APPLICATION NO.	FILING DATE	FIRST NAMED INVENTOR	ATTORNEY DOCKET NO.	CONFIRMATION NO.
10/771,522	02/05/2004	Junpei Ogawa	023971-0371	3059

Office Action Summary

OGAWA ET AL.

ATTACHMENT

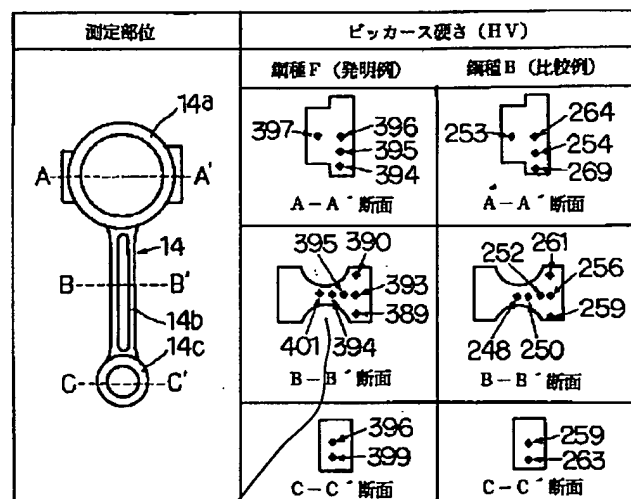
Regarding claim 1, JP'317 teaches a connecting rod comprising:

a connecting beam section (at 14b in Fig. 11(D). See Attachment) serving as a main body of the connecting rod;

a first joining section (Att.) located between the connecting beam section (Att.) and the big end 12a, 13a, 14a to connect the connecting beam section (Att.) and the big end 12a, 13a, 14a; and

a second joining section (Att.) located between the connecting beam section (Att.) and the small end 12c, 13c, 14c to connect the connecting beam section (Att.) and the small end 12c, 13c, 14c;

wherein each of the first and second joining sections (Att.) gradually and continuously decreases in cross sectional area toward the connecting beam section (Fig. 12) and has a strength distribution in which a strength increases with a decrease in the cross sectional area.
